# SERVICE - INFO

**LuK Nr: 128 0055 11 – 280mm DBVR**

**Bulletin 988 2000 960**

**CASE IH, MANITOU, VOLVO\*\***

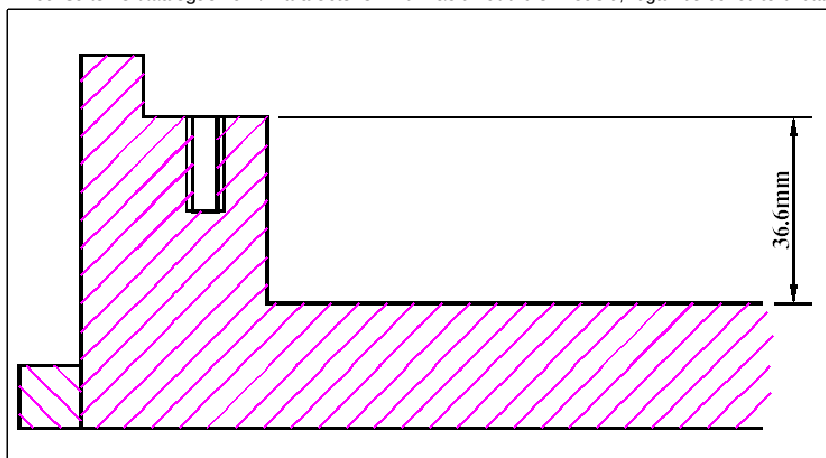
| <b>Info:</b>        | <b>128 0055 11 replaces / ersetzt / remplace / sustituye a / sostituisce 128 0055 40 + 128 0055 41</b>                                                                                                                                                                                                                                                                                                                                                                                                                       |

| <b>(GB)</b>         | Please ensure that the flywheel is machined to a pot depth of 36.6mm.                                                                                                                                                                                                                                                                                                                                                                                                                                                        |
